**Department of Energy**

As the Carlsbad Area Office (CAO) continues to develop responses to EPA issues provided in the December 19, 1996 letter to Al Alm, we are partially submitting them to you in order that you may begin reviewing them without awaiting completion of all items. This is the third response package. As in the earlier submittals, we have reproduced the issue verbatim from the December 19, 1996 letter and inserted the CAO response in each case. We are confident that you will find this supplemental information helpful in your review process. We will continue to provide additional packages as they are completed (about one each week).

DOE's Response to the EPA's Request for Additional Information on the WIPP Compliance Certification Application

Figure 2. Regions in which hydraulic conductivity of Rustler units has been affected by post-depositional geologic processes. (Corbet and Knupp, 1996)

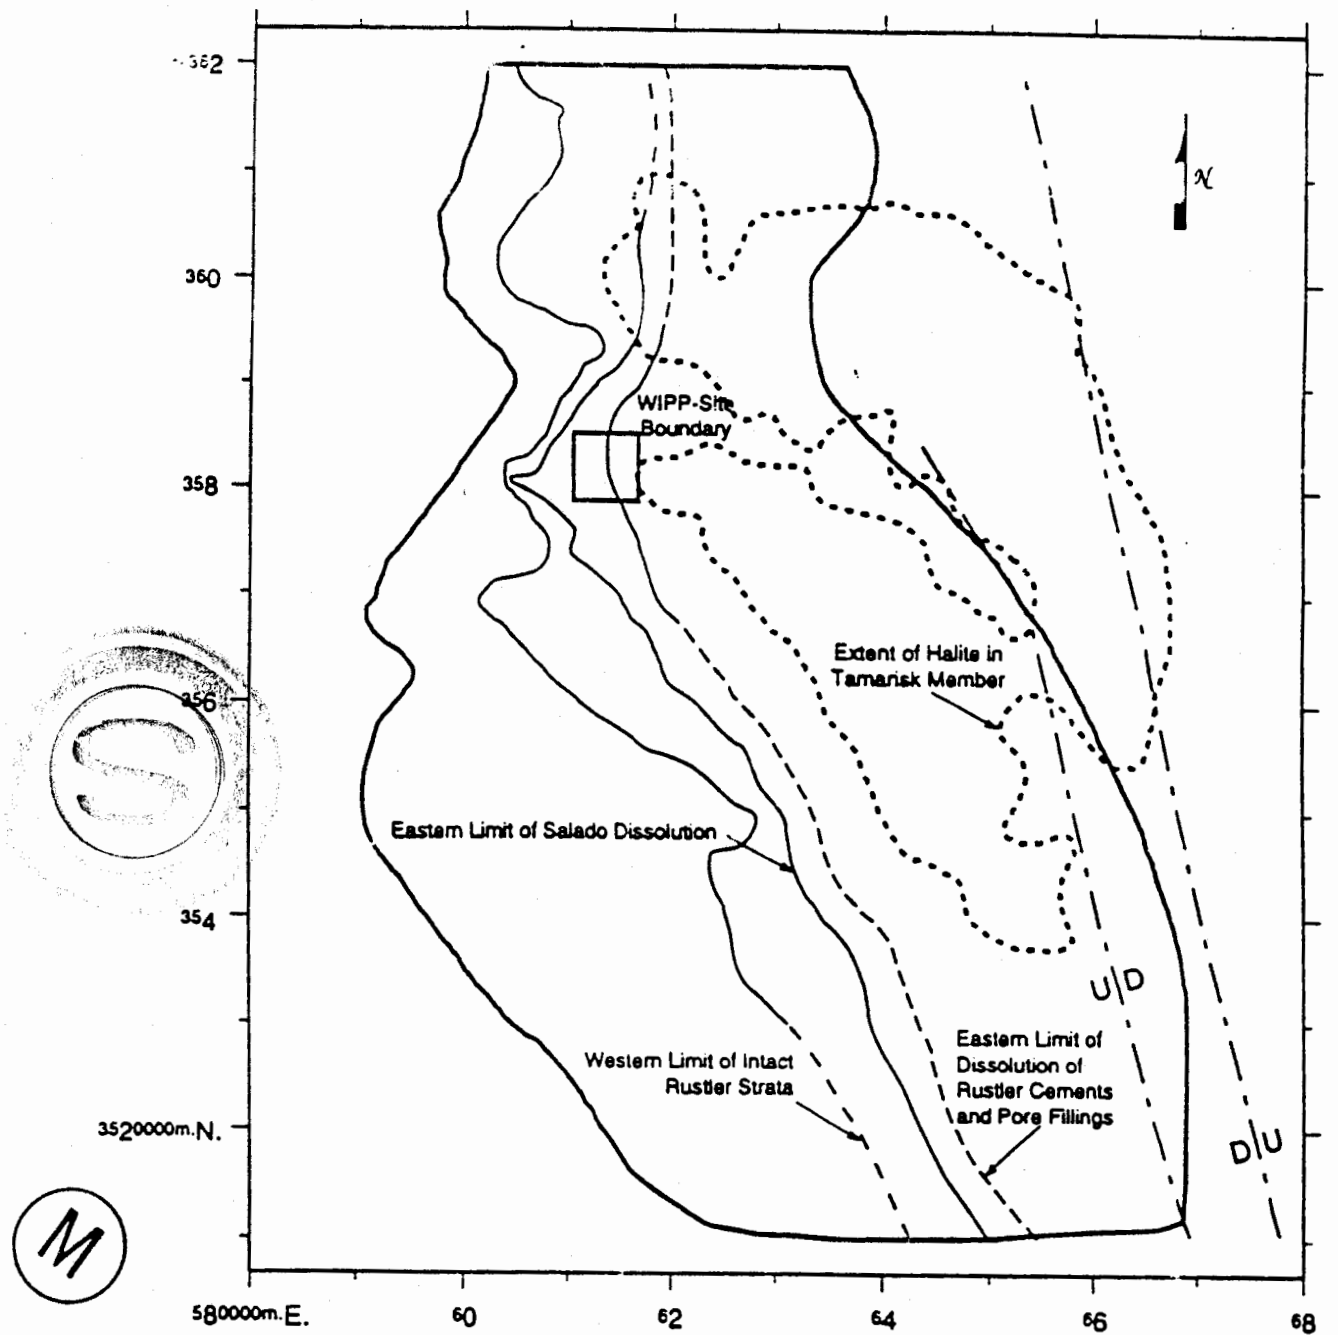
(2) The Culebra is described as having heterogeneous transmissivity (CCA page 6-124, line 2-3) and uniform porosity (CCA page 6-129, line 20-26). Given the fact that flow in the Culebra is conceptualized as being predominantly in fractures, the porosity should vary with hydraulic conductivity (and transmissivity since the thickness is constant).

*Future changes in the Culebra transmissivity due to dissolution need to be discussed, or reasons need to be given for discounting this alternative conceptualization of the Culebra.*

Figure 2 shows how the simulations included the effects of dissolution of Salado halite and gypsum in Culebra fractures. A description of these processes from Corbet and Knupp (1996) follows:

*Dissolution of Pore- and Fracture-Filling Minerals.* Evaporite minerals (halite, gypsum, or anhydrite) fill much of the pore space and fractures in intact Rustler units (Holt and Powers, 1988; Beauheim and Holt, 1990). Over portions of the map area, moving groundwaters have dissolved these minerals and have thereby locally increased hydraulic conductivity. For example, past dissolution of cements and fracture fillings is thought to be an important control on the pattern of hydraulic conductivity of the Culebra in the vicinity of WIPP.

Nash Draw is located in the region west of the WIPP site and west of the line marking the western limit of intact Rustler strata in Figure 2. Note that the simulations consider a region of Nash Draw-type deformation over a region that is much larger than Nash Draw itself. Note also that dissolution of fracture filling is assumed to have increased Culebra permeability over the western half of the WIPP site (i.e., to the west of the line labeled "eastern limit of dissolution of Rustler cements and pore fillings"). Figure 3 shows how these processes were represented as zones in the simulations. Upper Salado dissolution (Zone 2) was assumed to increase the permeability of the Culebra by an order of magnitude. Dissolution of fracture fillings (Zones 2 and 3) was assumed to increase the permeability of the Culebra by 1.5 orders of magnitude.

Figure 4. Gypsum saturation versus depth.. Data points with values less than -0.5 are from the upper portion of the Dewey Lake.

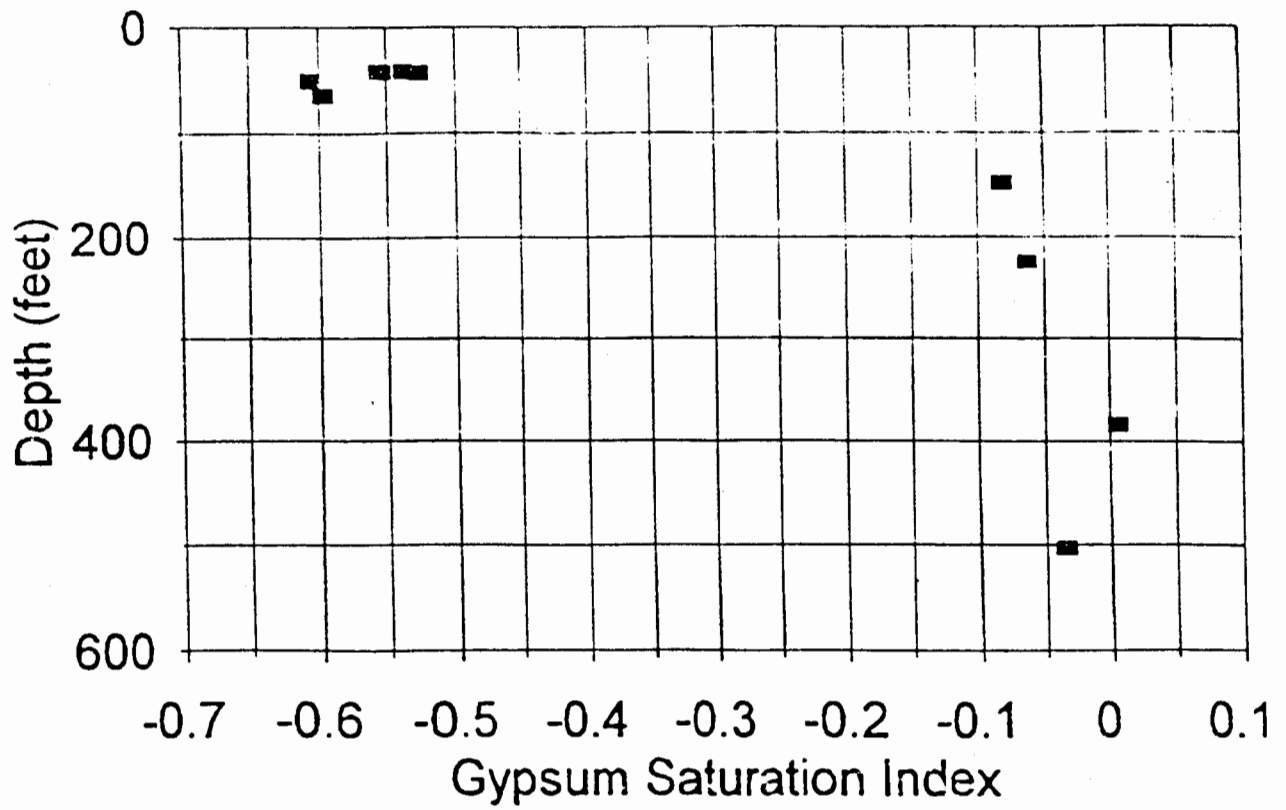
Anderson (1995) presents an argument that dissolution of gypsum is presently occurring in the Culebra in a region of high transmissivity in the southern portion of the WIPP site. This region of high transmissivity is important because many of the potential release paths in performance assessment flow and transport calculations pass along this region. Anderson's position is logically based on a map published by Beauheim and Holt (1990) showing Culebra waters in this region to be undersaturated with respect to gypsum. However, as noted above, the equilibrium calculations that that figure was based on are now known to be in error and have been superseded by calculations presented by Siegel, Robinson, and Myers (1990). Consequently, the most recent equilibrium calculations do not support Anderson's hypothesis that gypsum is presently being dissolved in the Culebra in the vicinity of the WIPP site.

The current dominant flow path of groundwater entering the Culebra is vertical leakage from overlying units. Chemical analyses of groundwater samples obtained from these overlying units were used to determine  $SI_{gyp}$  with the EQ3NR solubility/speciation code (Wolery, 1992). Results are shown in Table 1 and are plotted as a function of depth in Figure 4. The uppermost five samples were obtained in the vicinity of the Exhaust Shaft from the upper Dewey Lake near the contact with the overlying Triassic units at depths between 43 to 65 feet. These samples were undersaturated with respect to gypsum ( $SI_{gyp} = -0.54$  to  $-0.61$ ). The Dewey Lake contains extensive gypsum cement, but this cementation only occurs at depths below ~100 feet. This is evidenced by the fact the next two samples from the Dewey Lake at depths of 148 and 225 feet are in equilibrium with gypsum ( $SI_{gyp} = -0.08$  and  $-0.06$ ). The two lowest samples are from the Magenta at depths of 384 and 504 feet, and are also in equilibrium with gypsum. ( $SI_{gyp} = 0.01$  and  $-0.04$ ).

This conceptualization, therefore, does not support the third and fourth points of Anderson's hypothesis. There is no indication that a change to a wetter climate would result in water that is undersaturated with respect to gypsum to be introduced to the Culebra. Instead, flow simulations, calculations of gypsum saturation as a function of depth, and calculations of mass transfers along flow paths support a conceptual model in which gypsum has not been dissolved from Culebra fractures over the past 600,000 years.

Figure 2-6. Regions in which hydraulic conductivity has been affected by post-depositional geological processes.

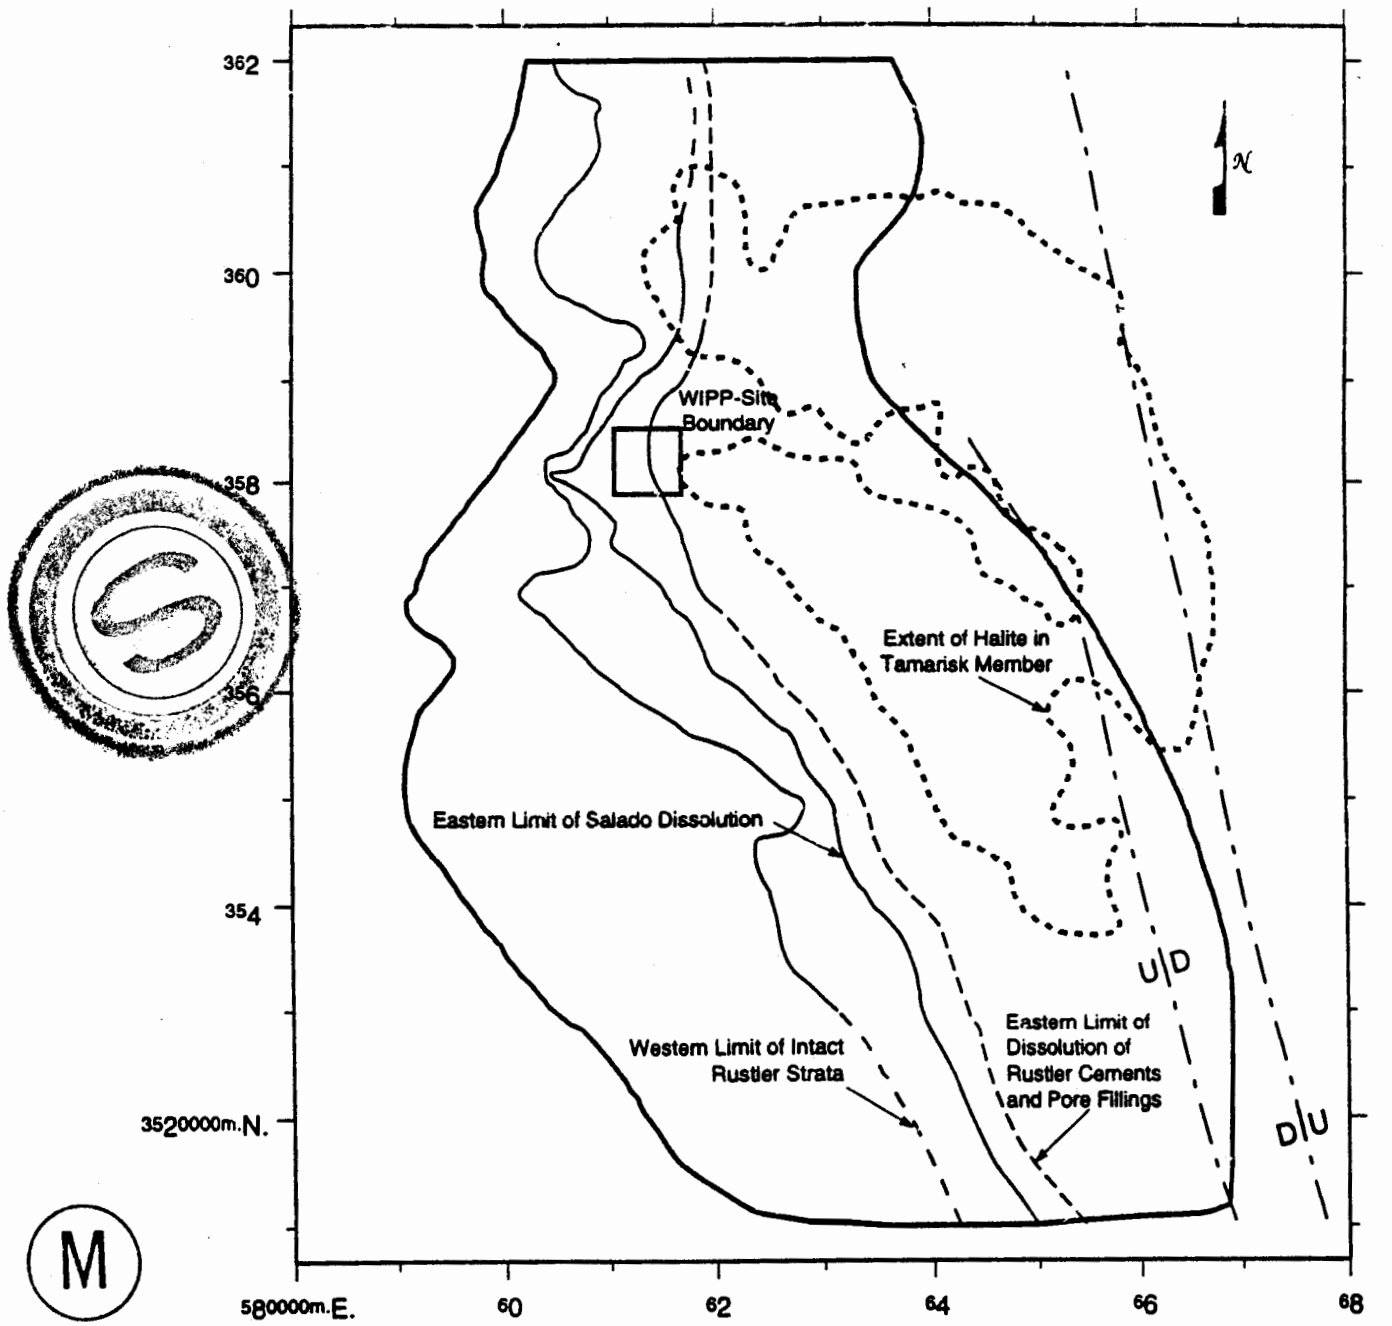
*The Department needs to determine whether there are any physical explanations for an artificially low transmissivity data point at P-18, and provide evidence to explain how one data point can produce low transmissivity in a region far separated from that data point. The transmissivity fields need to be calibrated with the P-18 data point removed to verify that the low transmissivity region is due to the single data point at P-18.*

M Regarding the physical explanation for the low transmissivity observed at P-18, the DOE recognizes that there is not independent test data from other, nearby, boreholes that confirm this value. However, the low value observed at P-18 is consistent with the conceptual model of regional hydraulic conductivity adopted by Corbet and Knupp (1996). P-18 is the only borehole of those used for calibrating the transmissivity distribution that is located in a region in which the Culebra was assigned a very small hydraulic conductivity for the purpose of simulating regional groundwater flow. The low conductivity for this region was based on a conceptual model of how geologic processes have modified the hydraulic conductivity of rocks above the Salado Formation. Specifically, P-18 is in a region of the Culebra that underlies halite deposits in the Tamarisk member. The following description of this region is from Corbet and Knupp (1996).

The extent of this region of low hydraulic conductivity is indicated by the dashed line labeled "Extent of Halite in Tamarisk Member" in the attached figure (Figure 2-6 of Corbet and Knupp). Within this region, the hydraulic conductivity was assumed to be two orders of magnitude less than that of intact Culebra that does not underlie halite deposits.
